United States Patent and Trademark Office

APPLICATION NO.	FILING DATE	FIRST NAMED INVENTOR	ATTORNEY DOCKET NO.	CONFIRMATION NO.	
09/530,156	08/31/2000	Oliver Hecker	AP9472	3844	
10291	7590 04/18/2002				
RADER, FISHMAN & GRAUER PLLC			EXAMINER		
39533 WOODWARD AVENUE SUITE 140 BLOOMFIELD HILLS, MI 48304-0610		(10	BURCH, MELODY M		
		010	ART UNIT	PAPER NUMBER	
			3683	3683	
			DATE MAILED: 04/18/2002	DATE MAILED: 04/18/2002

DETAILED ACTION

Fig. 8

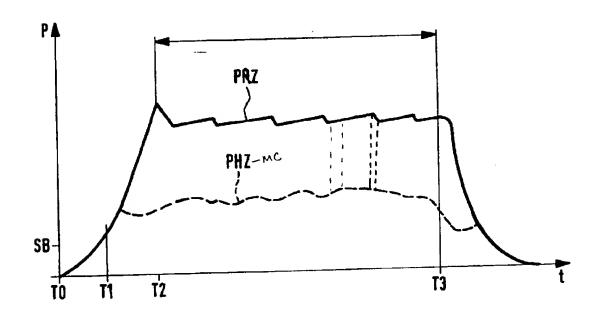
Re: claims 1, 10, 11, 14, and 17-19. DE-19501760 shows in figure 8 a method of operating a brake assist system which comprises a first mode shown from T0 to T1 in which the brake assist system is not actuated, a second mode of operation shown from T1 to T3 and disclosed in col. 9 lines 32-36 in which after recognition of an emergency brake situation (the exceeding of a threshold) a pressure build-up of wheel brakes is generated, and a third mode of operation shown from T3 to the end of the x-axis and

Re: claim 13. It is inherent that the ratio of the wheel brake pressure and the master brake cylinder pressure is equal to some time dependent constant of proportionality or momentary value as evident from the plot of figure 8.

Re: claim 15. Pueschel et al. show in the area of the red perforated lines of the attached copy of figure 8 the limitation of declining the excess elevation function in time intervals in which the master cylinder pressure is declining as evident by the sharper decrease in the wheel brake pressure compared to the master cylinder pressure.

5. Claim 16 is rejected under 35 U.S.C. 103(a) as being unpatentable over DE-19501760 in view of US Patent 4798422 to Becker. Pueschel et al. show in the area of the grey perforated lines of the attached copy of figure 8 time intervals in which the master cylinder pressure is increasing. Although the wheel brake pressure is increasing in this interval as well, it is not disclosed or shown that the excess elevation function is kept constant in this time interval. Becker teaches in col. 5 lines 18-26 the use of brake control apparatus in which the wheel brake pressure is determined as a function of the master cylinder pressure and in which the pressure difference between the wheel brake pressure and the master cylinder pressure is monitored. It would have been obvious to one of ordinary skill in the art at the time the invention was made to have modified the system of Pueschel et al. with an interval in which the wheel brake pressure is directly proportional to the master cylinder pressure such that a wheel brake pressure increase mirrors a master cylinder brake pressure increase, in view of the teachings of Becker, in order to achieve a desired brake actuating comfort level.
